**MARTISWOODS HYDROPNEUMATIC PUMP STATION
ADDENDUM NO. 1**

This document consists of 12 sheets (9 - 8.5" x 11" and 3 - 11" x 17"). It is the responsibility of the Bidder to assure and guarantee by acknowledging the receipt of this Addendum in the Bid Forms, that the Bidder has received the addendum in its entirety, and that the Bidder accepts all conditions contained herein.

After Page 02225-5, insert Figure 02225-1.

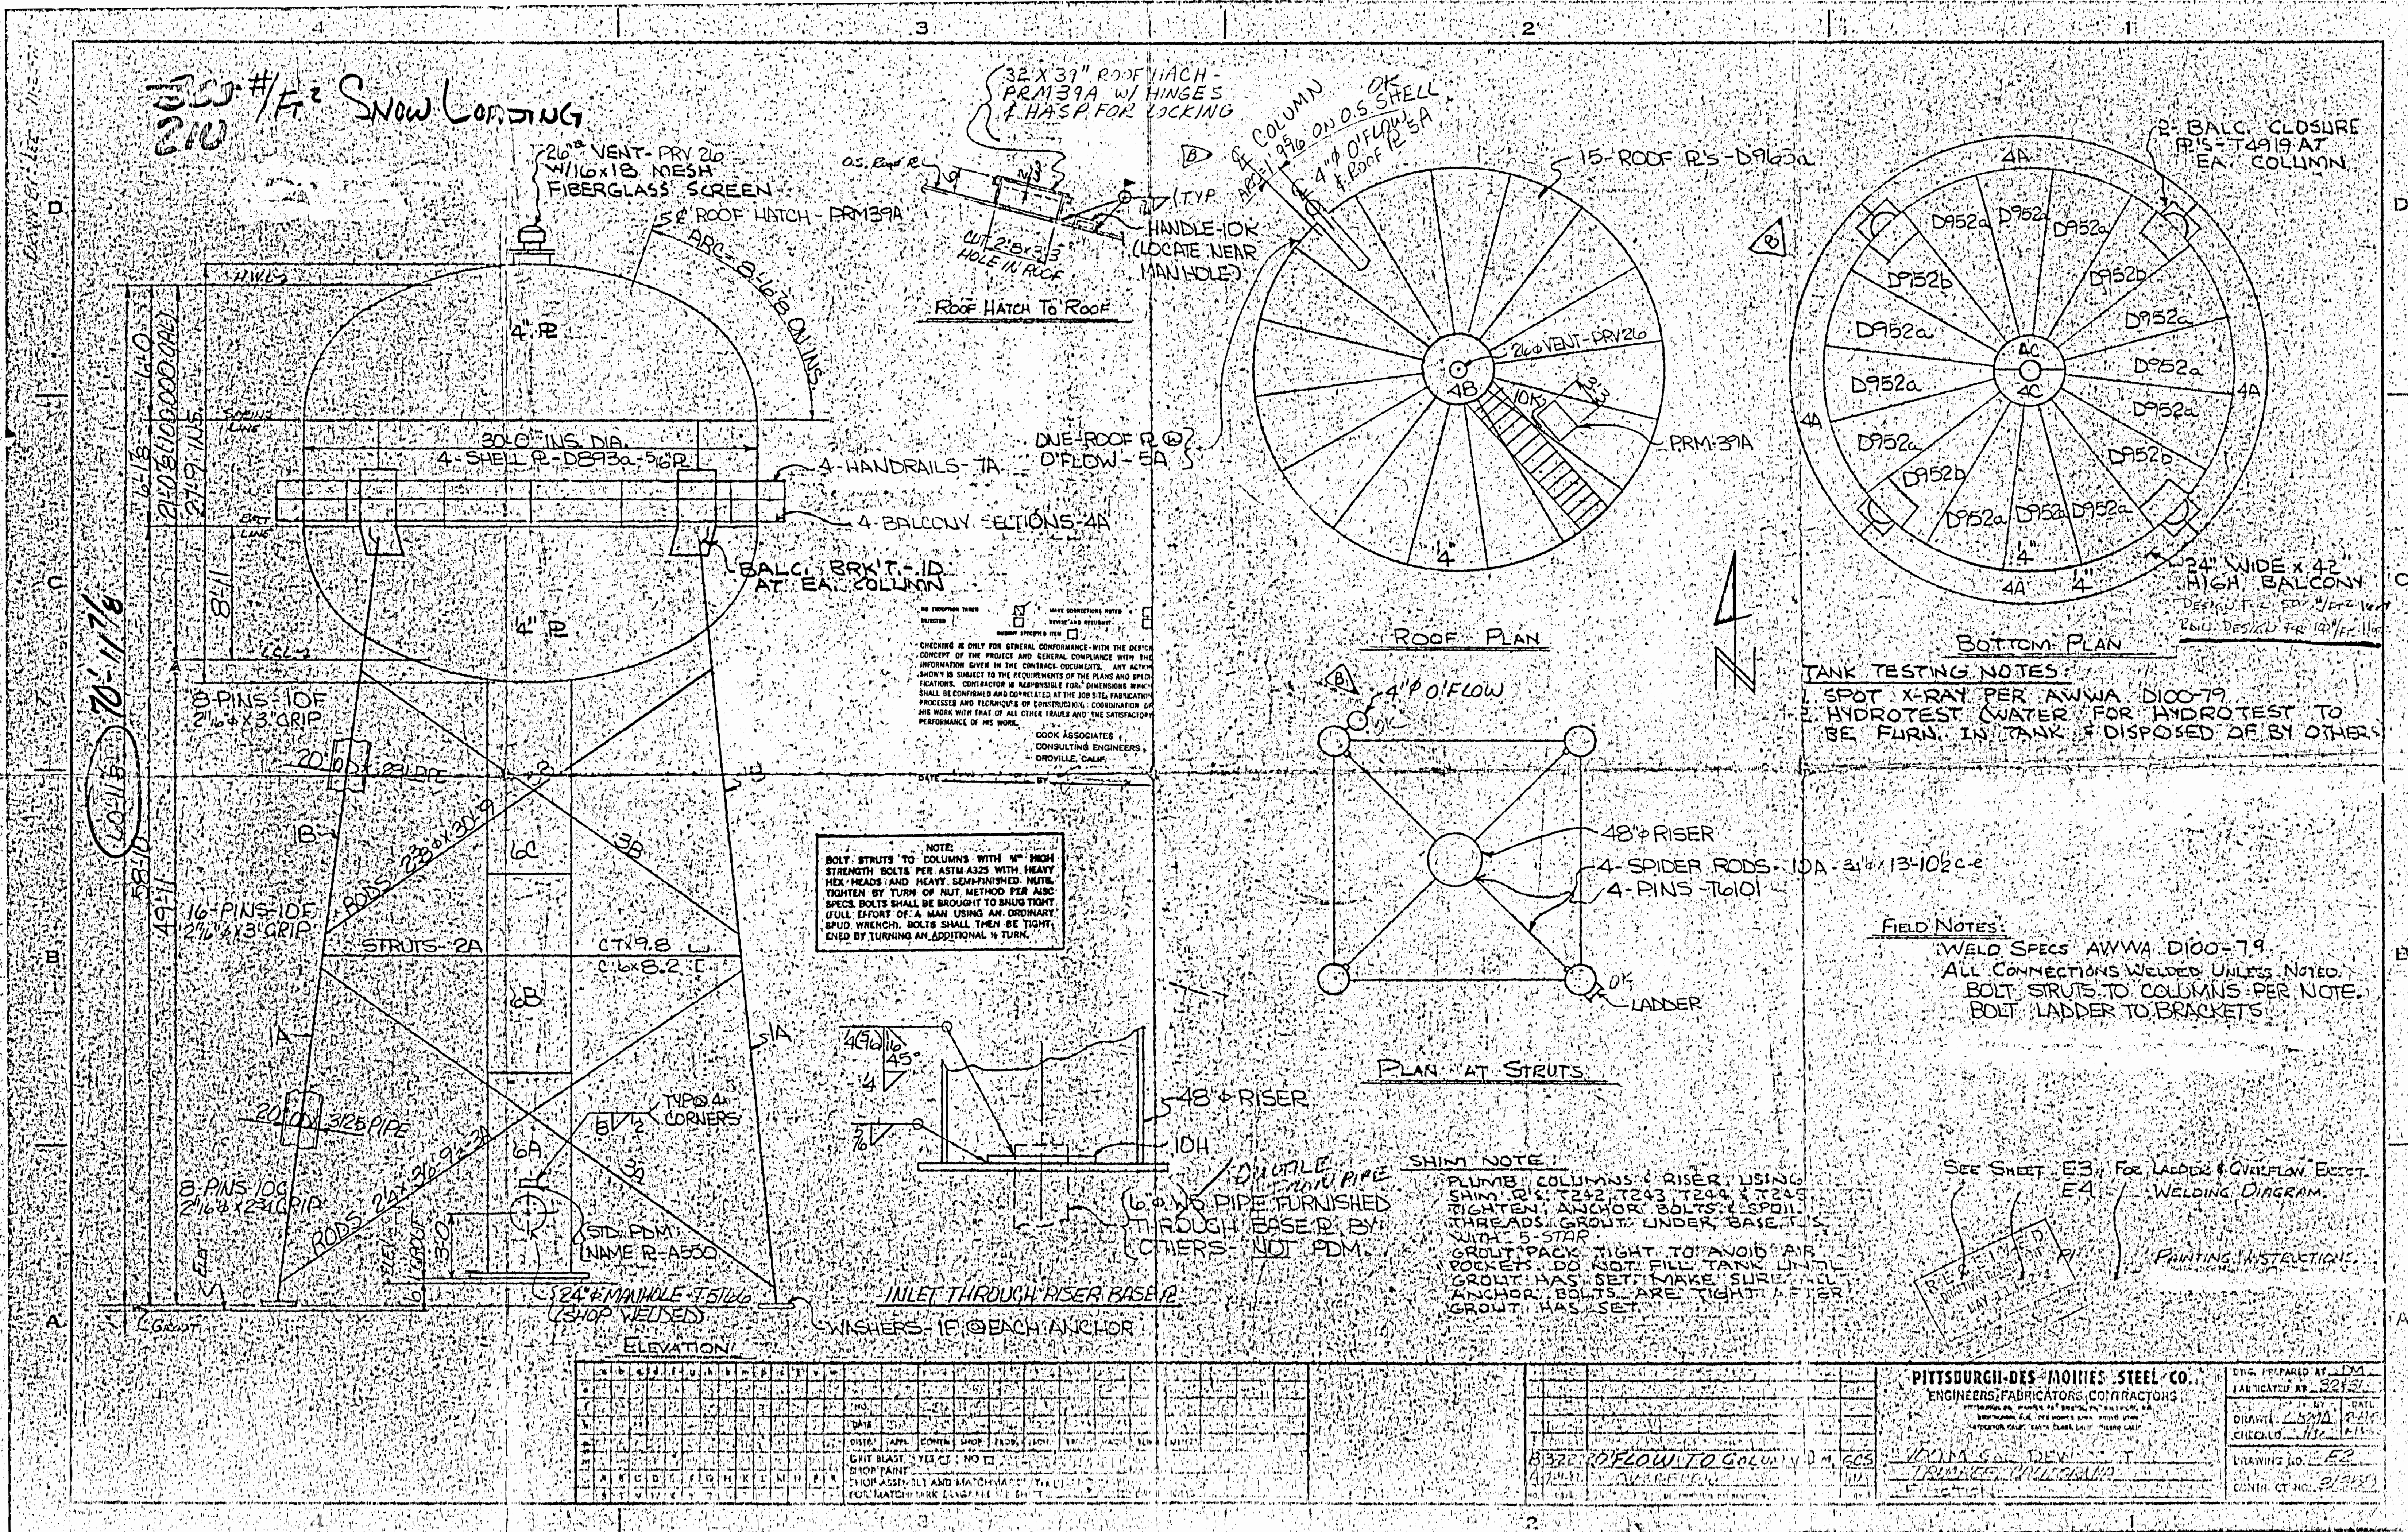
“K. A fabrication drawing for the existing elevated tank is given in Figure 02225-1. This figure was produced by the steel tank fabricator. The DISTRICT does not have any other fabrication drawings related to the elevated tank and its foundations. This figure is provided for information purposes only and the DISTRICT cannot verify whether the information contained in the drawing is accurate.”

TRUCKEE DONNER PUBLIC UTILITY DISTRICT
MARTISWOODS HYDROPNEUMATIC PUMP STATION
LIGHTING AND GROUNDING PLAN
PLACER COUNTY
CALIFORNIA

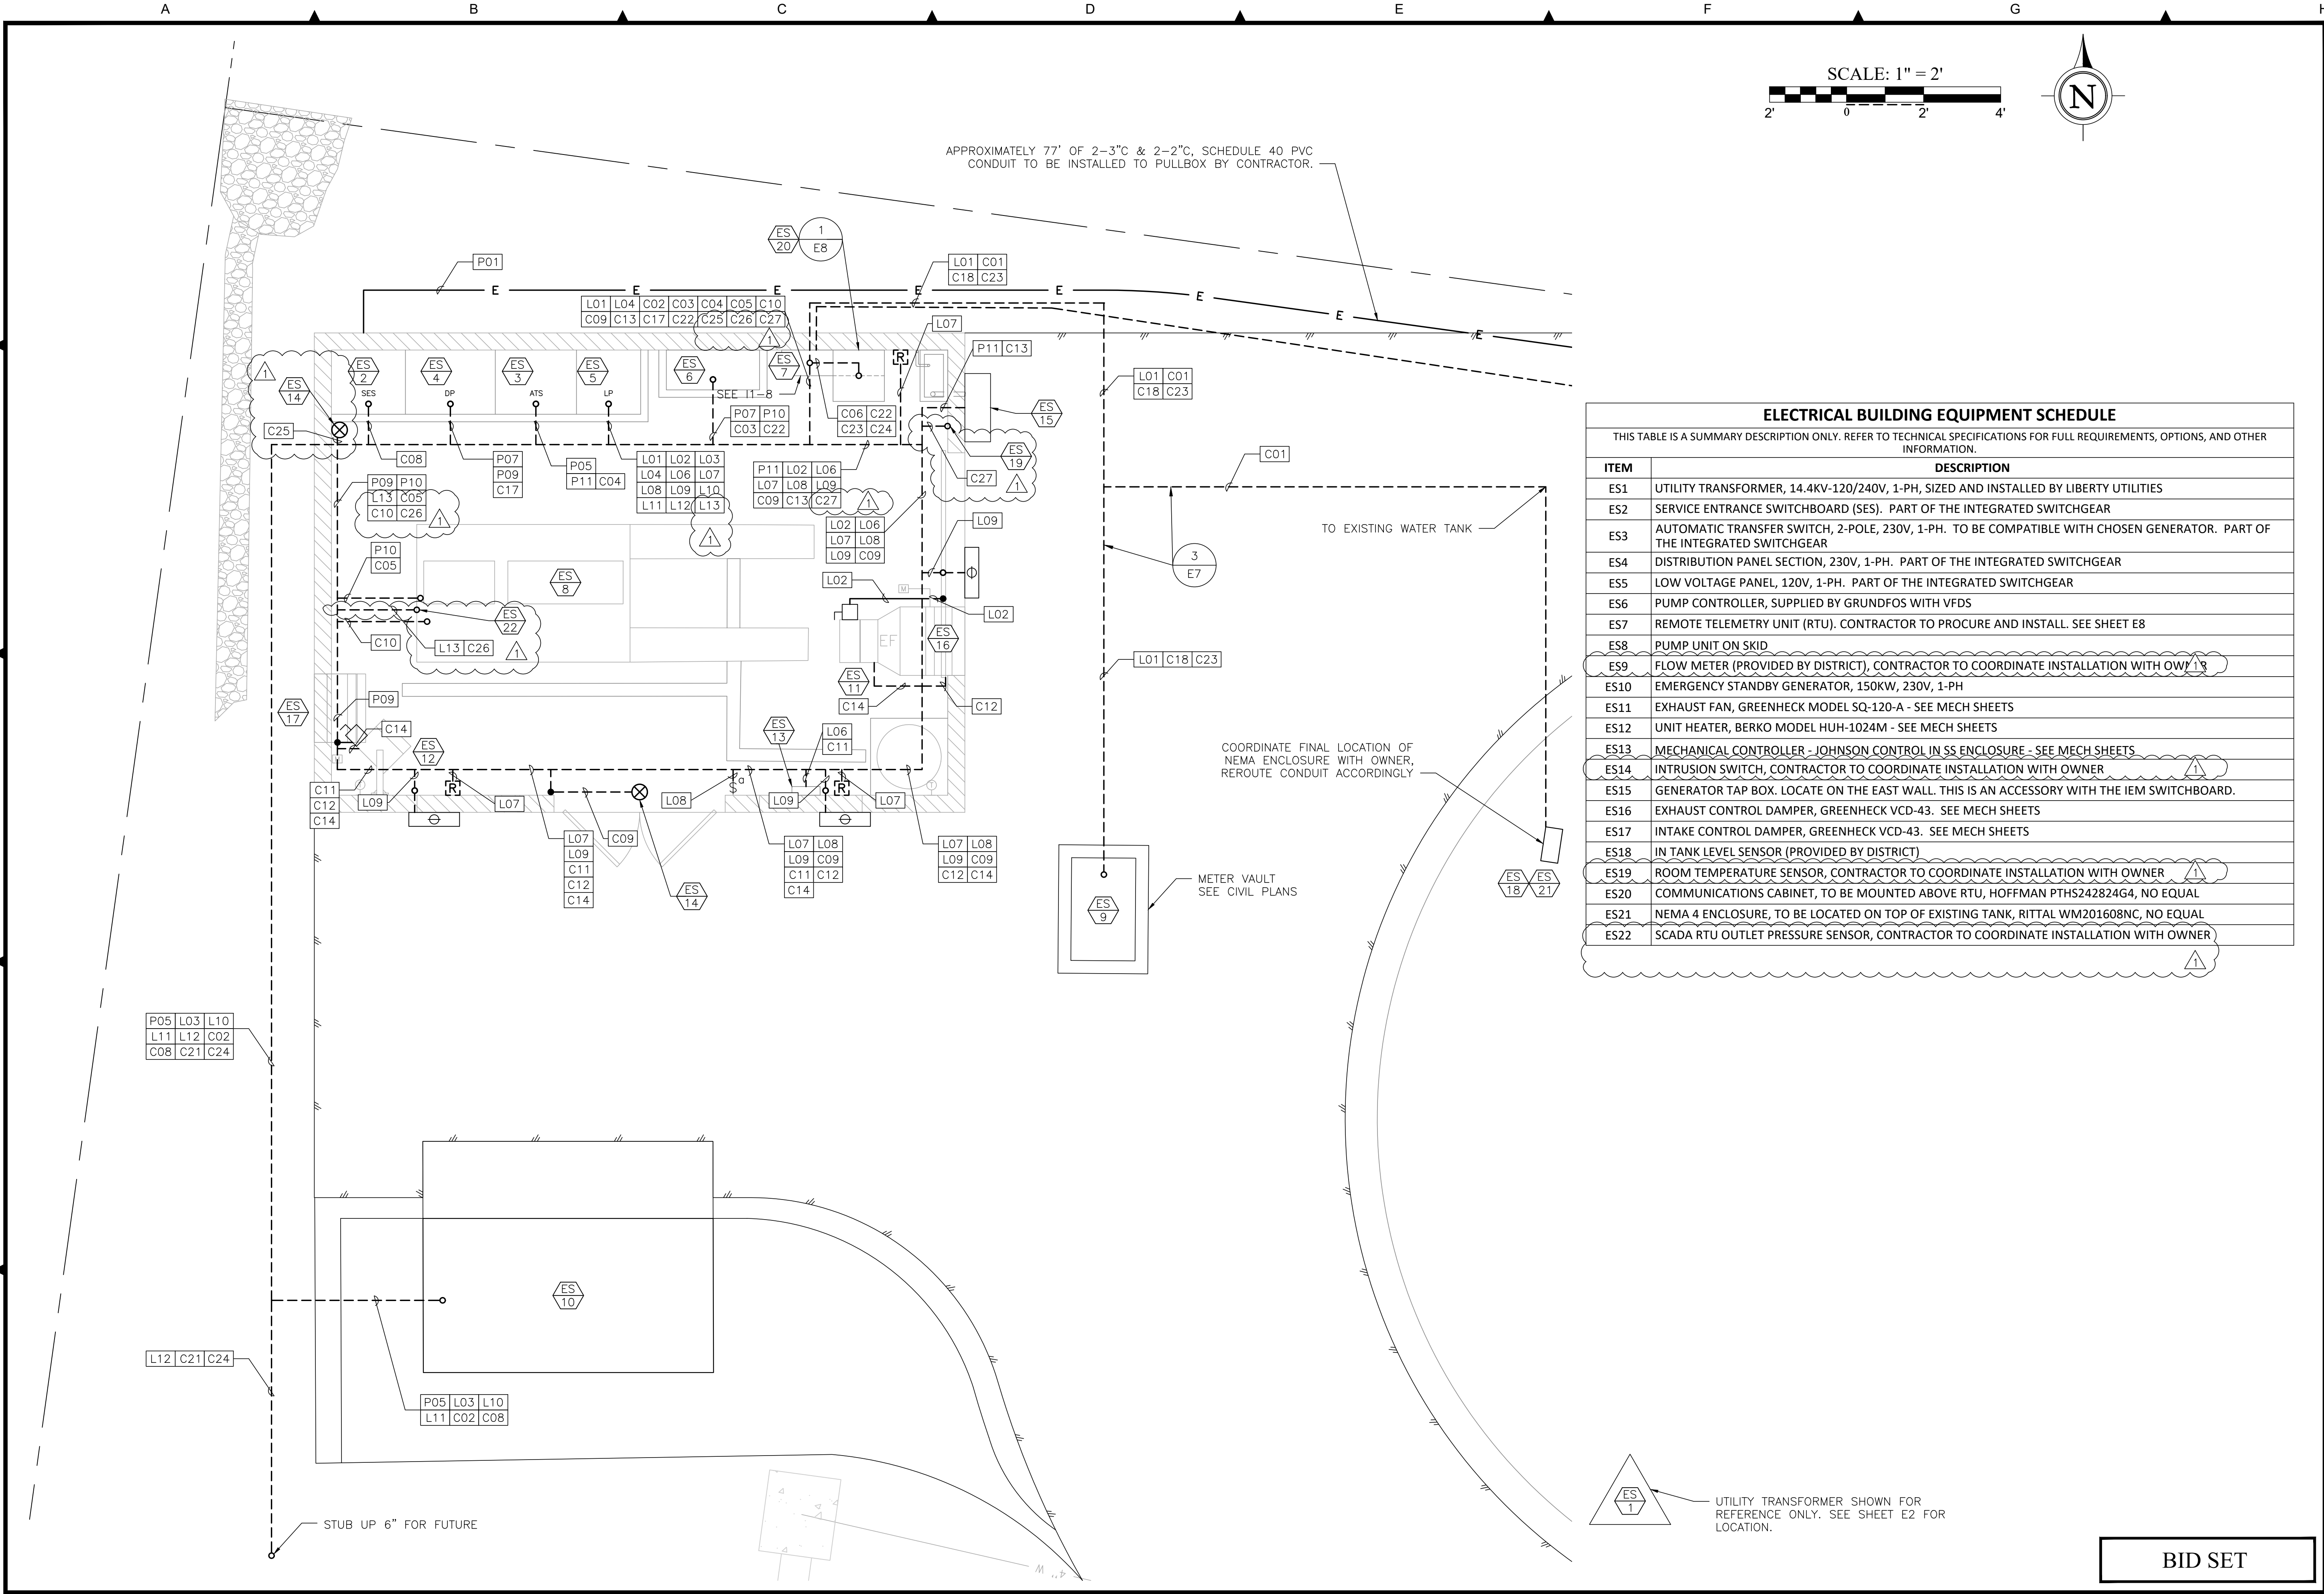
8. DRAWING E-5 – LIGHTING AND GROUNDING PLAN

Delete Drawing E-5 in its entirety and replace it with Drawing E-5 (dated 9/16/2021) included in this addendum.
